Subject: A/YL-LFS/564

A/YL-LFS/564
回應土力工程署的擬問

Comments of the Head of Geotechnical Engineering Office, Civil Engineering and Development Department (Contact Officer: Mr. Jeremy WONG; Tel: 2760 5790)

(2SW-C/C84) (2SW-C/C85)
Location Plan

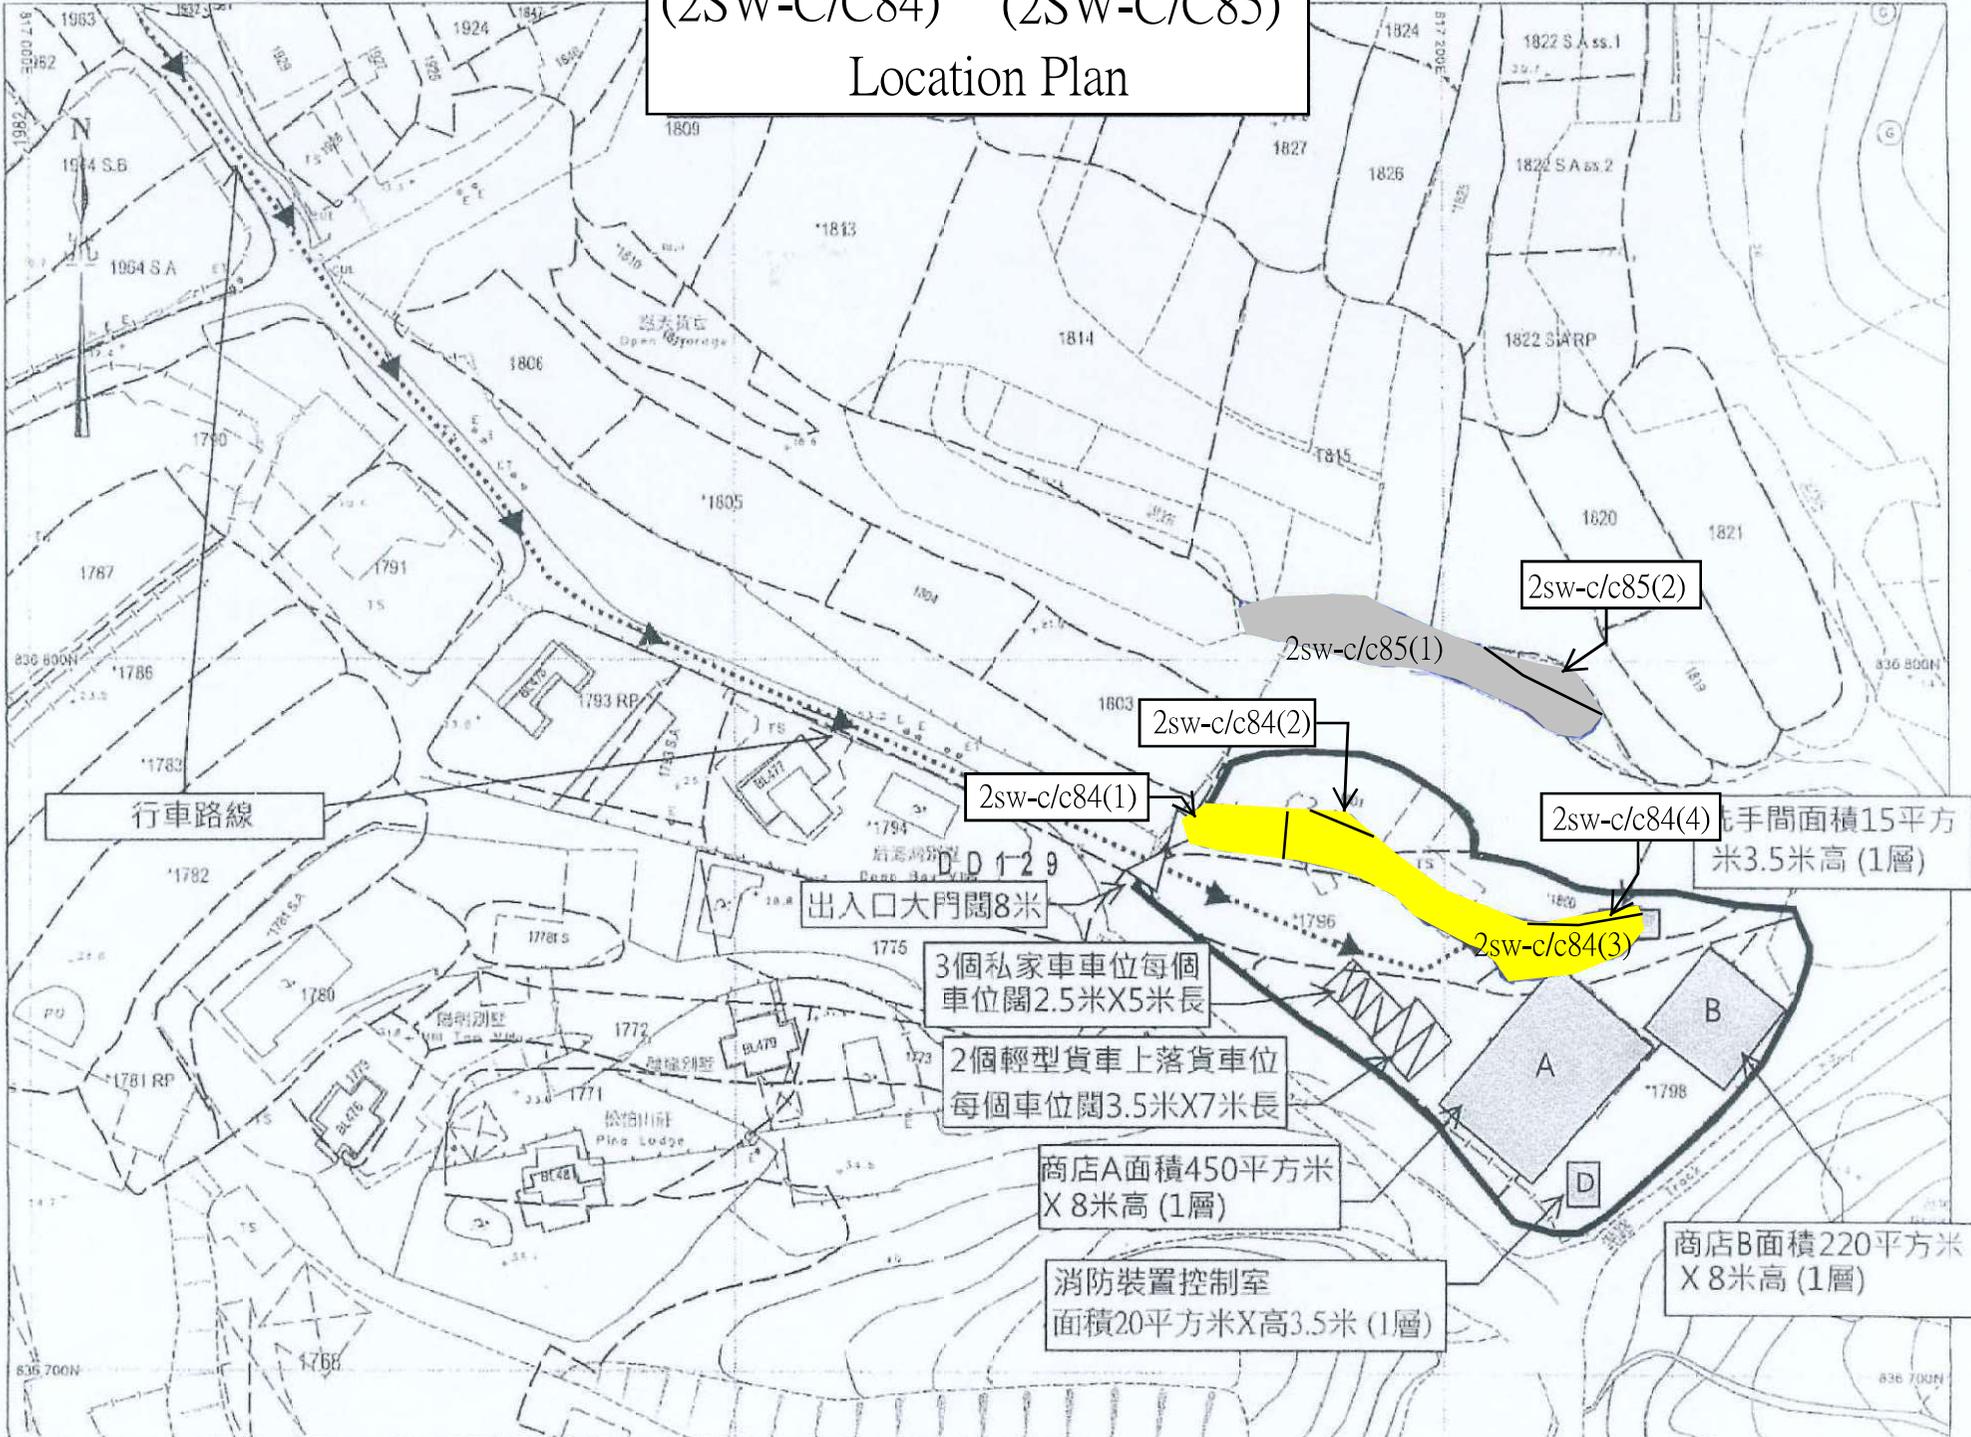
2. It is noted from Section 2.4 of the GPRR that feature nos. 2SW-C/C84 and 2SW-C/C85 have now been flattened into a gentle sloping ground after some filling works has been done. Please ask the applicant to show the feature boundaries clearly on the survey plan and provide sufficient cross-sections cutting across the proposed site and the whole features to demonstrate that the features would not affect or be affected by the proposed development.
